**Information Requirement (IR) Response Table – Denison's Response to December 2023 FIRT Comments, February 2024**

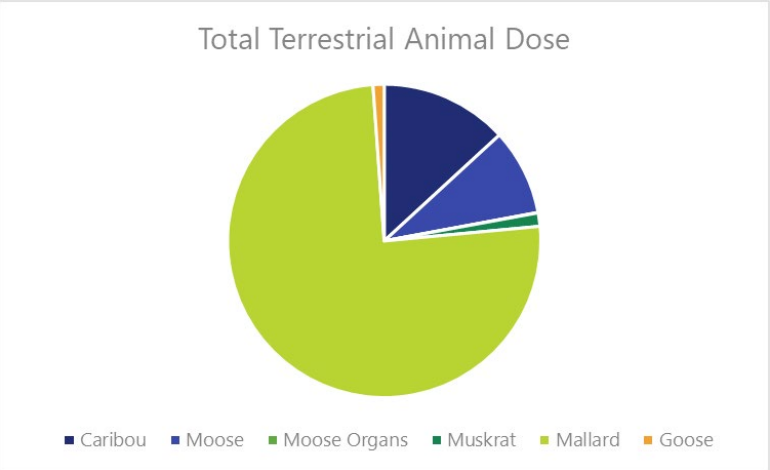
IR-194	-	ECCC	Aquatic species	Appendix 10-A (ERA), Section 3.1.1.2 and Section 3.1.2.3	<p><b>Context:</b> In the ERA, COPCs should be selected for further assessment based upon the following factors:</p> <ol style="list-style-type: none"> <li>COPC concentrations in effluent that exceed selected water quality guidelines for the protection of aquatic biota, and</li> </ol>	1. As noted in IR-114, provide the information on predicted effluent quality for COPCs with required monitoring under the MDMER.	<p>This response has not been accepted, as the Proponent has not updated the ERA to assess elevated baseline concentrations to delineate potential Project effects from background conditions.</p>	1. See response to IR-114. Additional information has been provided for COPCs with requirement for monitoring under Schedule 5 of MDMER. Note that predicted effluent quality for all Schedule 5 parameters, with the exception of mercury, nitrate, and phosphorous were provided in Table 3-1 of the ERA in Appendix 10-A (these constituents were not identified as COPCs in the ERA).	<p>Yes</p> <p>Appendix 8E, Table 8.2-9, Table 8.2-10</p>

<p>Updated information has been added to Appendix 10-A, including Table 3-3, Table 3-5, Figure 3-2 and Figure 3-3, as well as Table 3-1 of Appendix A of Appendix 10-A.</p> <p>The revised text in Section 3.1.2.1 (Appendix 10-A) is as follows:</p>	Waterbody	Average Depth (m)	Area (km <sup>2</sup> )	Average Outflow (L/s)	Retention Time (day)	Retention Time (month)	Reference Kratchkowsky Lake	2.9	0.80	331.2	80.66	2.69	Whitefish Lake North	1.6	0.26	1379.3	3.53	0.12	Whitefish Lake Middle	1.1	0.10	1398.5	0.88	0.03	Whitefish Lake South	1.0	0.32	1414.3	2.65	0.09	McGowan Lake	5.5	1.49	1832.3	51.61	1.72	Russell Lake Inlet	3.0	0.75	2390.3	10.92	0.36	<p>Yes</p> <p>Appendix 10-A, Section 3.1.2.1, Table 3-3, Figure 3-2, Figure 3-3</p> <p>Appendix 10-A, Section 3.1.2.2, Table 3-5</p> <p>Appendix 10-A, Section 3.1.2.3</p> <p>Appendix 10-A, Appendix A, Table 3-1</p>
Waterbody	Average Depth (m)	Area (km <sup>2</sup> )	Average Outflow (L/s)	Retention Time (day)	Retention Time (month)																																														
Reference Kratchkowsky Lake	2.9	0.80	331.2	80.66	2.69																																														
Whitefish Lake North	1.6	0.26	1379.3	3.53	0.12																																														
Whitefish Lake Middle	1.1	0.10	1398.5	0.88	0.03																																														
Whitefish Lake South	1.0	0.32	1414.3	2.65	0.09																																														
McGowan Lake	5.5	1.49	1832.3	51.61	1.72																																														
Russell Lake Inlet	3.0	0.75	2390.3	10.92	0.36
